Lower Duwamish River Slip 4 Engineering Evaluation/Cost Analysis

Dr. Peter L. deFur
ESC

February 27, 2006

PCB levels are high in the inner part of slip 4 in surface & deep mud

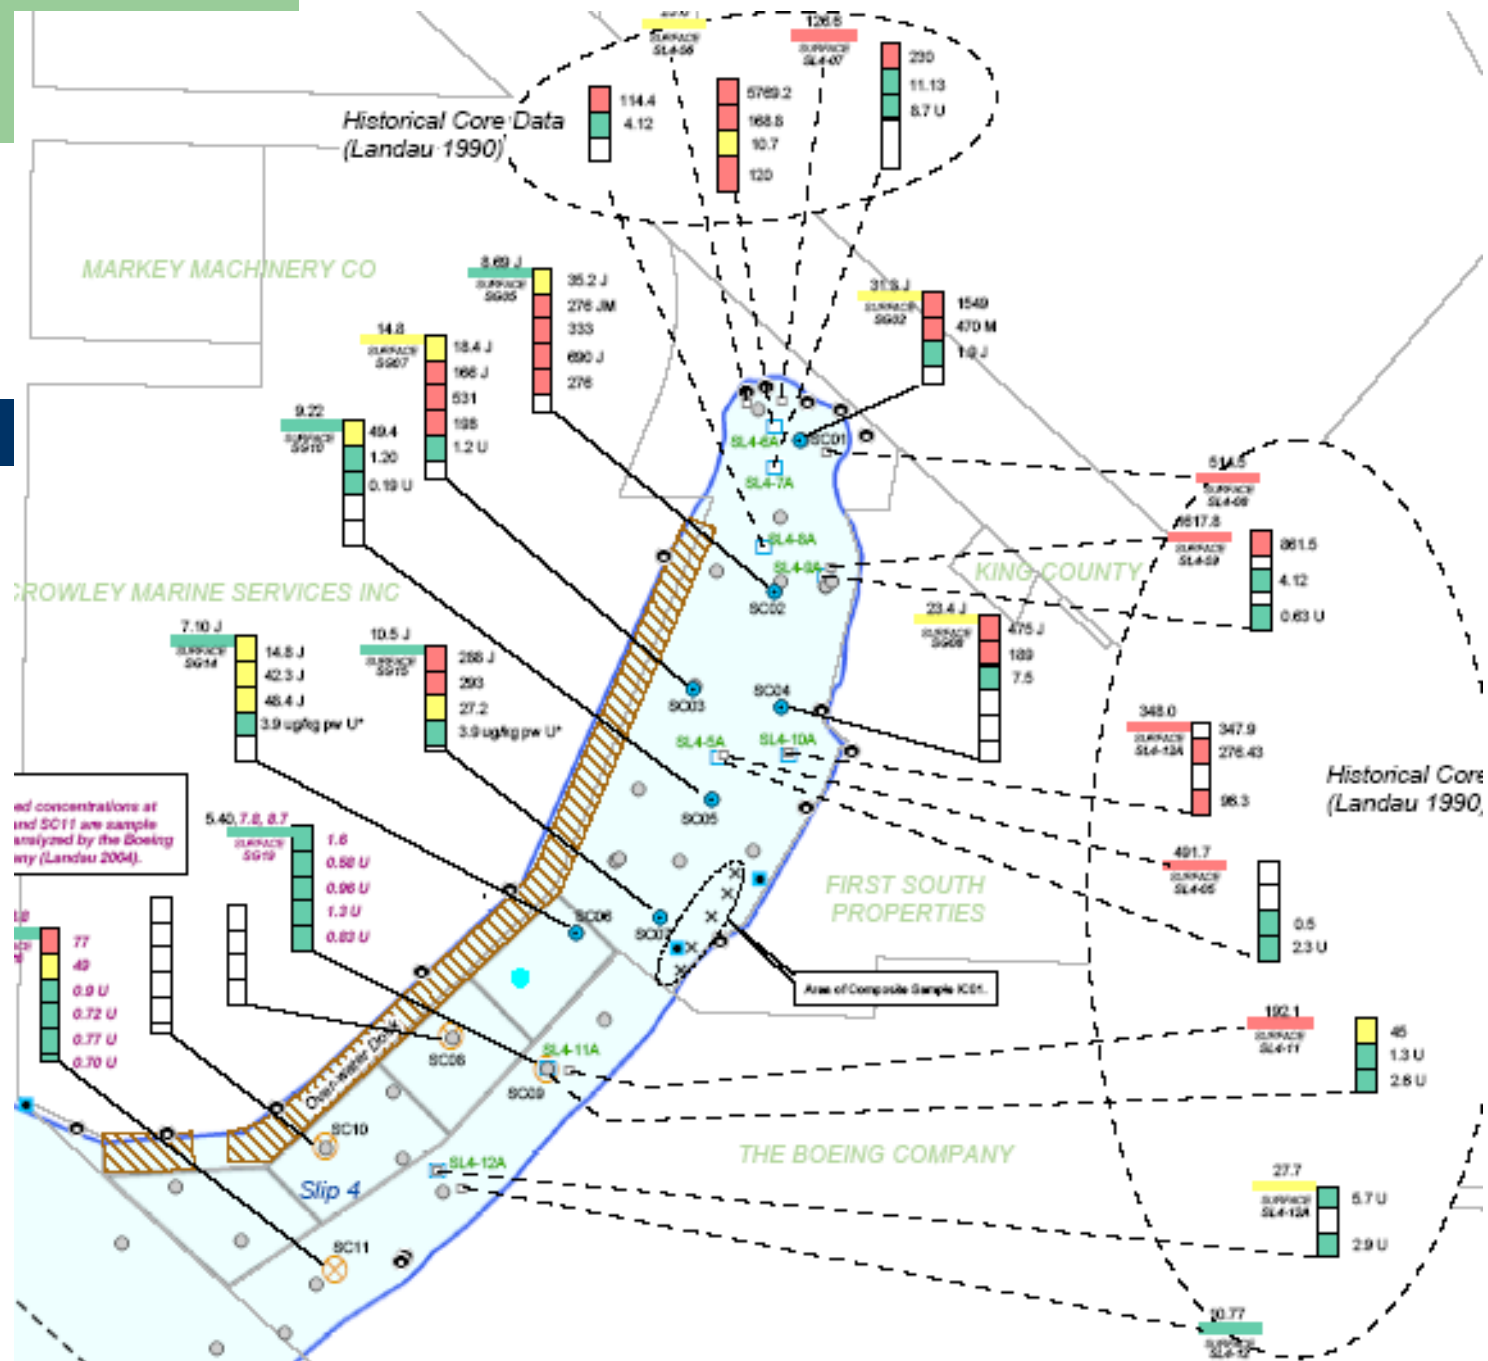
- No thorough documentation of the effectiveness of capping
- No data on groundwater flow beneath the slip- cap integrity from flow
- Source control is incomplete- Boeing absent from inspections, but PCB's in drains
- All options leave some contamination
- How to deal with scouring

- Must demonstrate the effectiveness of capping
- Must show that groundwater coming up beneath the bottom of slip 4 will not disturb the lower layers
- Dredge more of the most contaminated at SL4 10A
- Cap design has to be independently reviewed
